## ADDENDUM

NO. 1

**PROJECT NAME:** Lehman High School 2025 Additions and Renovations

**CLIENT NAME:** Hays CISD

PVR PLAN (SHEET 1 OF 2)

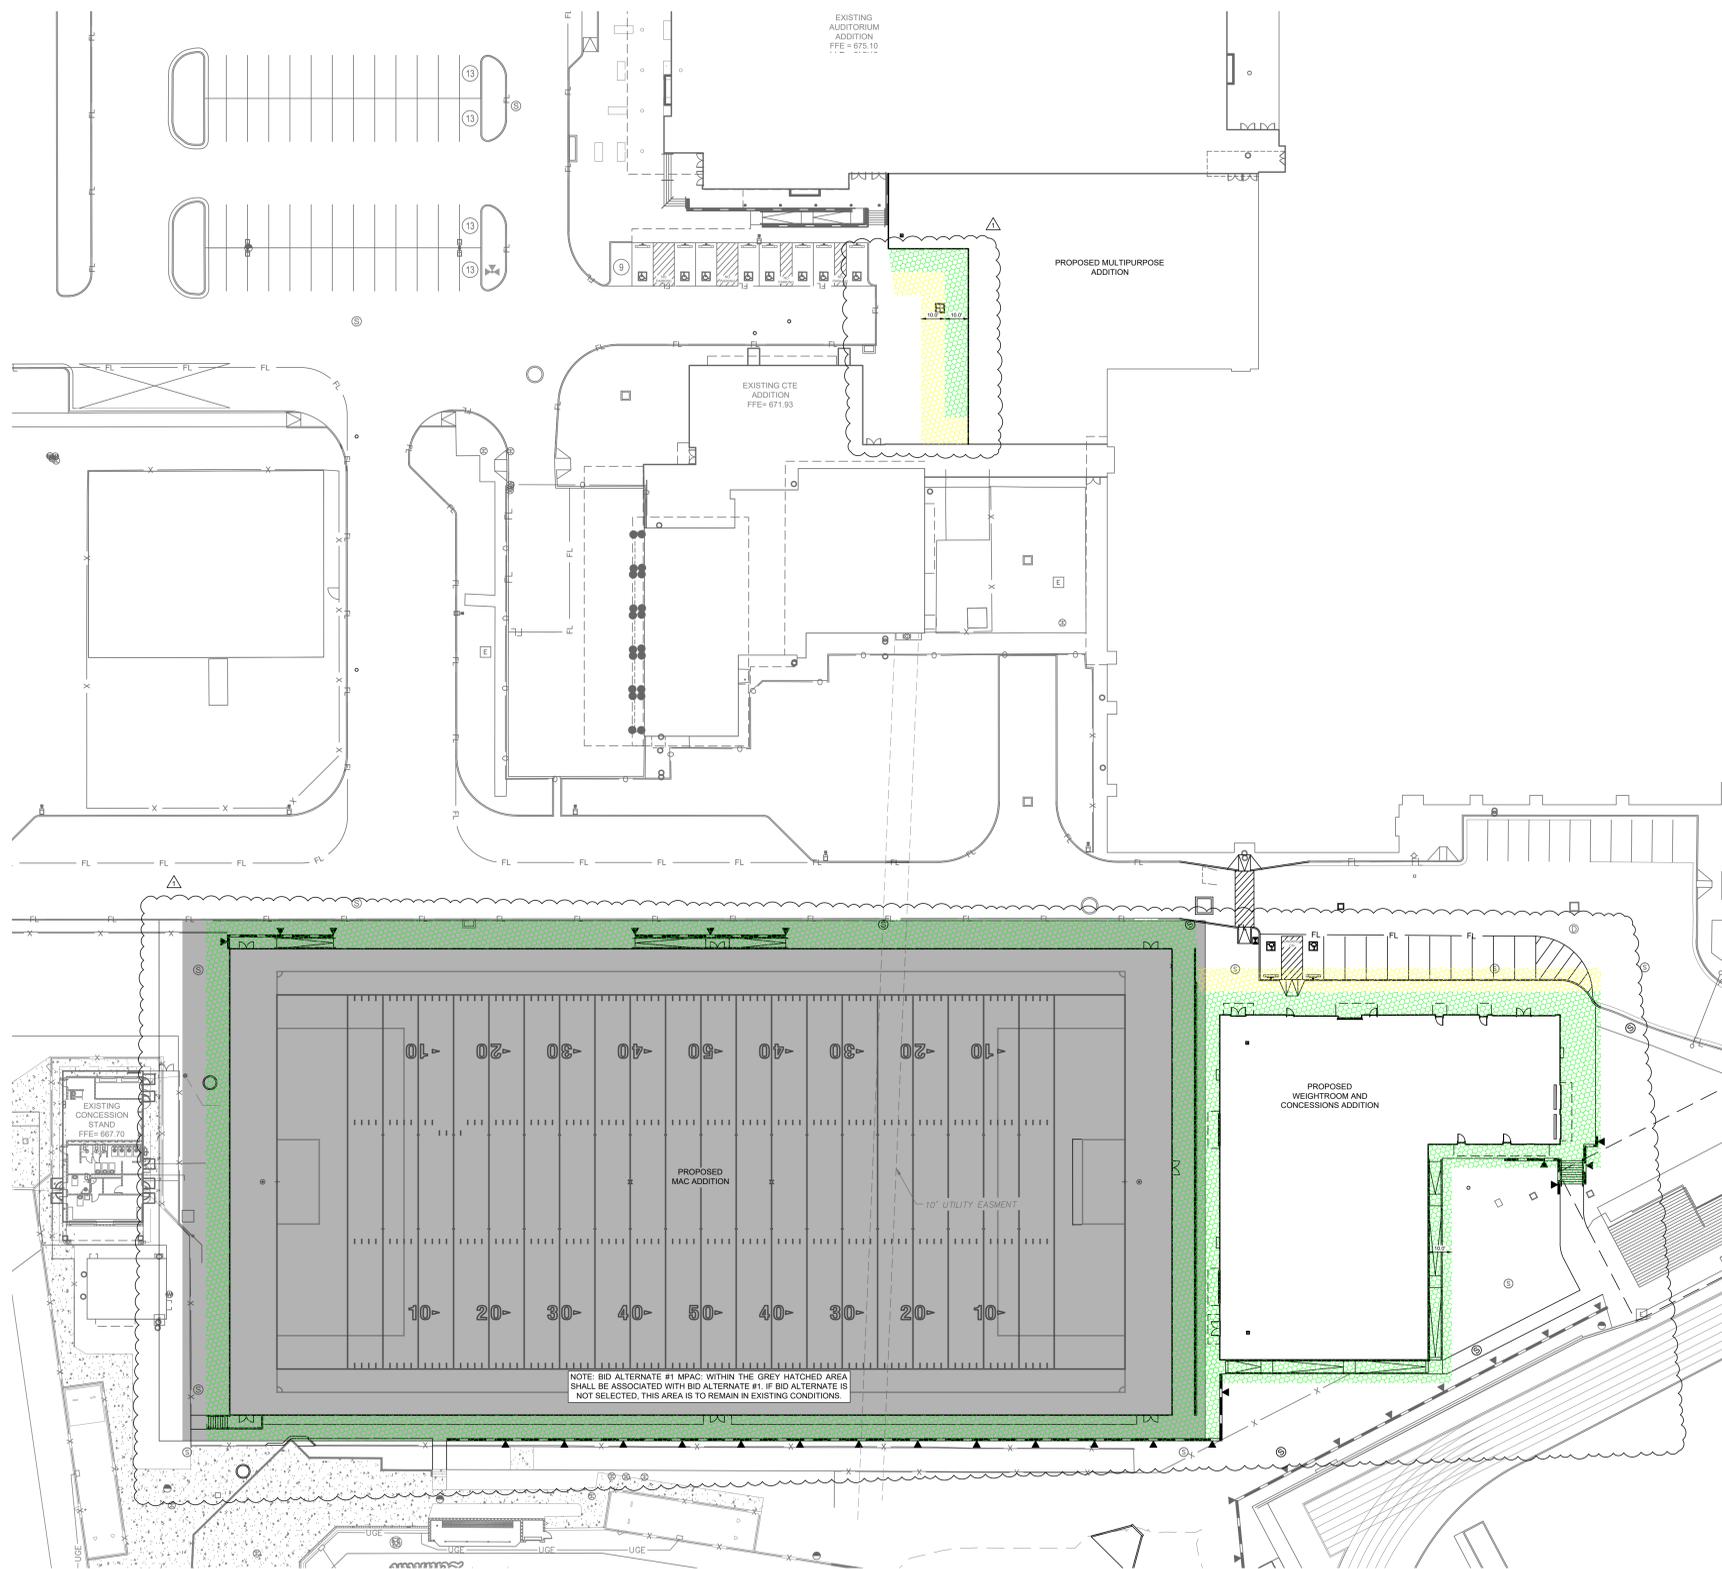
AD No 1, Civil Item 7: To the Drawings, Sheet C6.03, "PVR PLAN (1 OF 2),"

**PVR PLAN (SHEET 2 OF 2)**

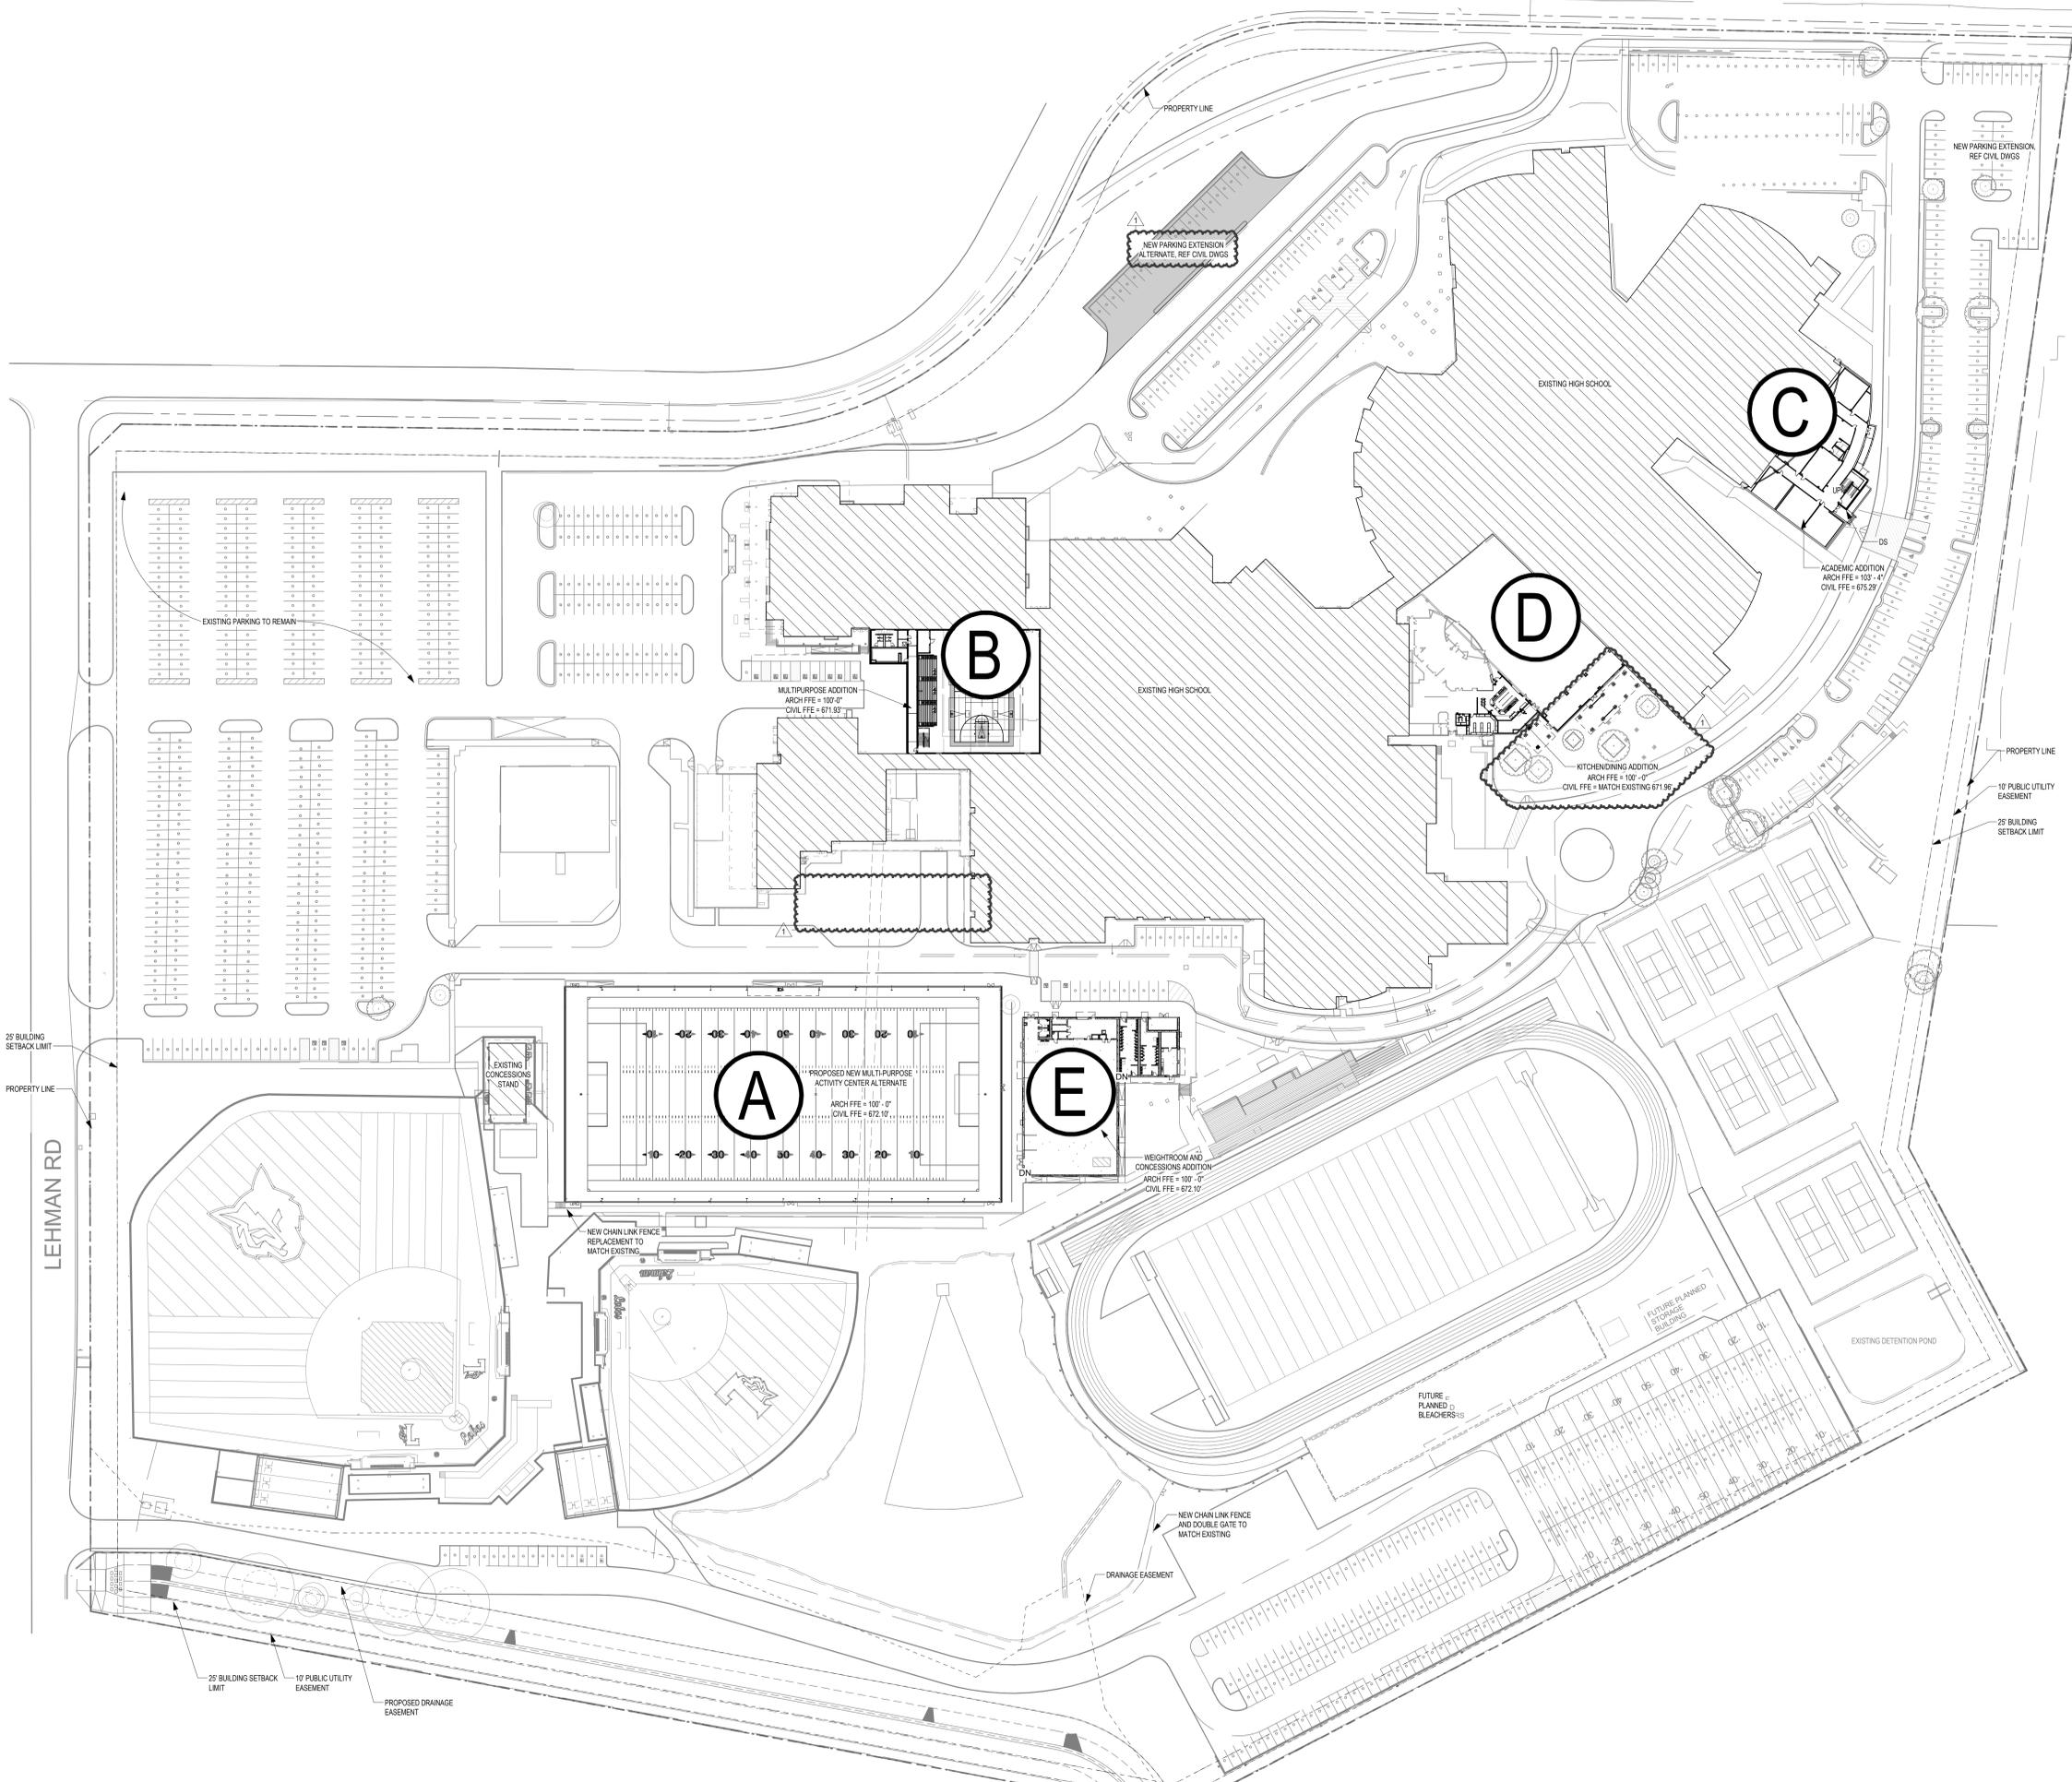
AD No 1, Civil Item 8: To the Drawings, Sheet C6.04, "PVR PLAN (2 OF 2),"
